7th Avenue Streetscape

Summary of Change Orders Issued

Change Order #3: \$17,958.62

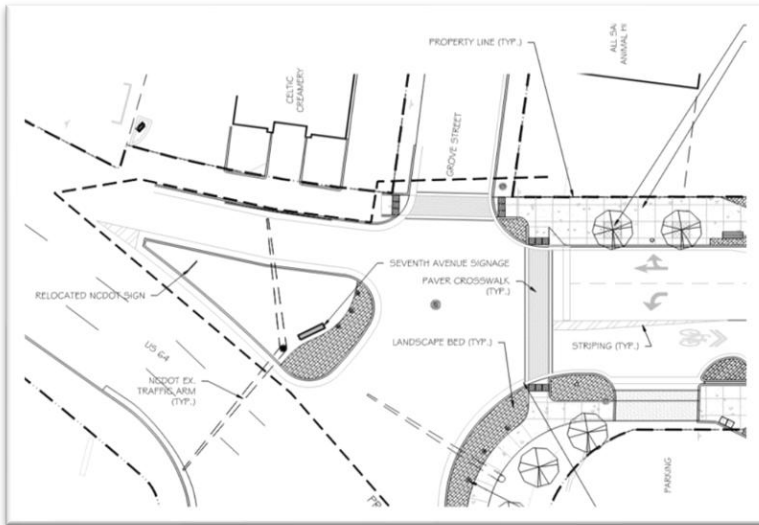
Change order 3 was issued due to extra-depth concrete in the existing sidewalk. Included in the scope of the project was work to remove all existing sidewalk along both sides of Seventh Avenue from N. Grove Street to Maple Street. The contractor expected that the existing sidewalk depth would be four inches, but encountered concrete depths up to ten inches. The increased concrete depth increased the labor and equipment costs associated with demolition and removal. This change order covers all costs associated with demolition and removal of the extra-depth sidewalk in all locations for the project.

Change Order #10: \$57,682.24 plus additional 45 Days

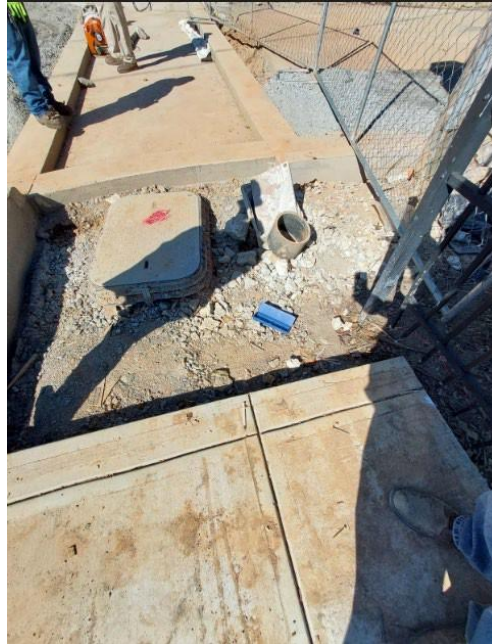
Change order 10 was issued due to the lengthy delay in utility relocation work. Duke Power was to replace existing utility poles with taller poles and other utilities, such as AT&T, were to relocate their lines as necessary. The delay in these utilities to complete this work directly impacted the contractor's ability to complete some of the contract work. As a result of this delay the contractor was required to keep staff on location and maintain on-site accommodations beyond the original contract time (December 4th, 2025). It was determined by City staff that the contract allowed the general contractor to request additional compensation for their general conditions.

CO 1008. Ramp, landing, and steps at Mission.

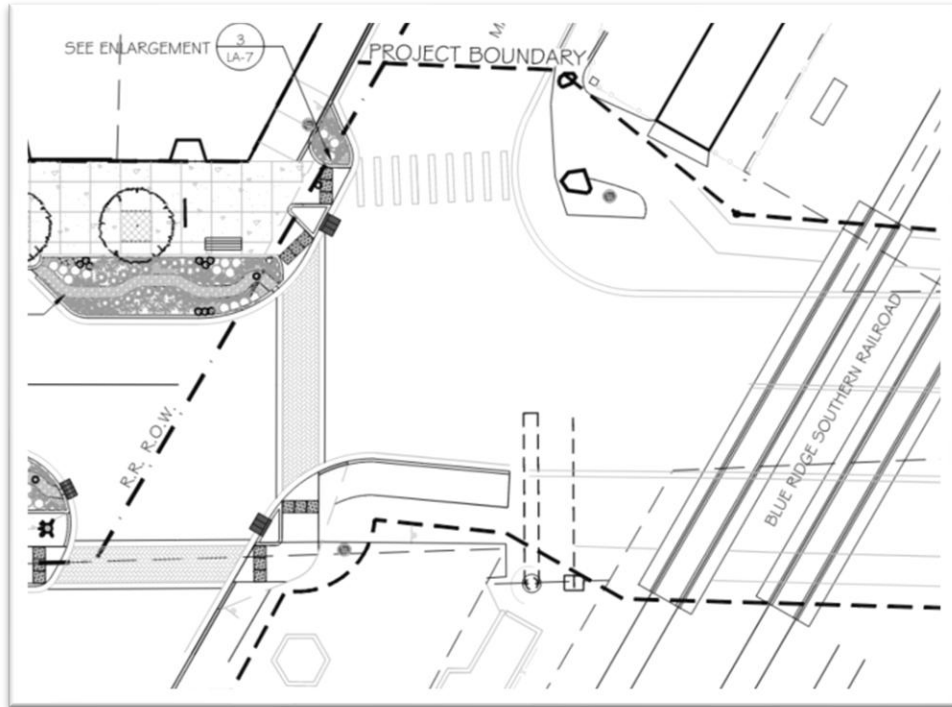
Change order 1008 was issued for “unsuitable soils” on the south side of Seventh Avenue the same as previously described for this type of work on the north side of Seventh Avenue. This also included the addition of a concrete ramp and steps in front of the Mission entrance and additional sidewalk work associated with the landing near the Depot and tying into the existing curbing at the railroad tracks.
